PLANNING, ZONING, & BUILDING DEPARTMENT
PZ&B Staff Combination Memorandum: Architectural Commission and Town Council

SUBJECT: ARC-24-0080 (ZON-24-0042) 141 ATLANTIC AVE (COMBO)

MEETING: NOVEMBER 22, 2024 ARCOM
DECEMBER 11, 2024 TC

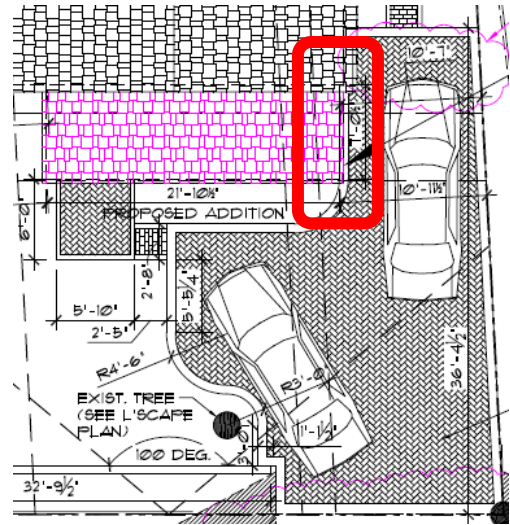
The application is for the removal of an existing front porch of a single-family residence to allow for a first-floor expansion of approximately 110 SF. The addition will create additional living room space and present a new covered entry to the existing front door. The current configuration of the driveway and front porch do not meet the minimum side setbacks, and the applicant proposes the new addition to align with the current building footprints east setback. The new construction will illicit one variance to align with existing nonconformity of the property, as the current structure is within the required setbacks. The proposed new addition will be setback 10.7' from the east side property line and span for 7'-0" in length.

| Code Section | Permitted | Proposed | Variance |
|--|---------------------------------------|--------------------------------|----------|
| Variance 1: Sec. 134-893(b)(7). | Minimum side yard setback of 12.5 ft. | East Side Yard Setback 10.7ft. | +1.8' |

EXISTING FRONT AND SOUTH ELEVATION

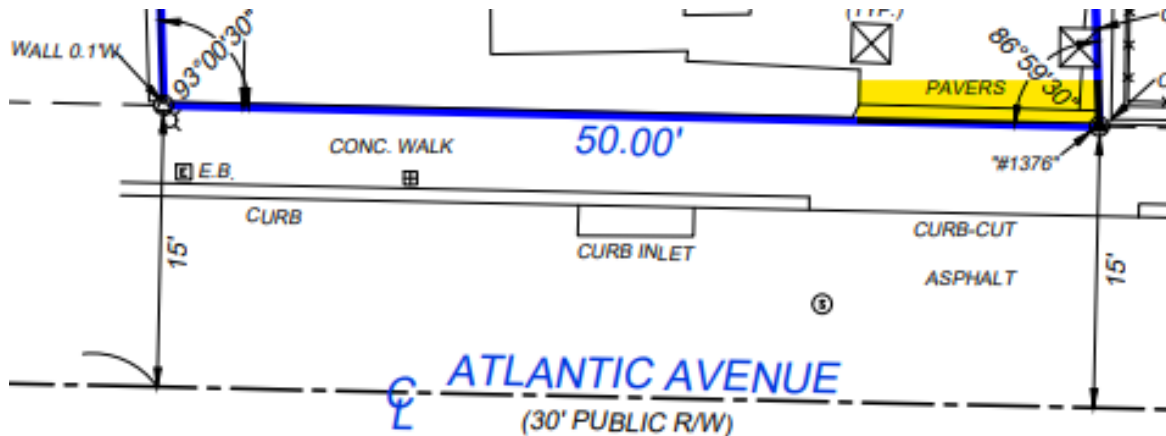
In addition, the applicant seeks to make changes to other elements of the existing façades including the removal of the louvered shutters and new railing designs on the front and rear entries.
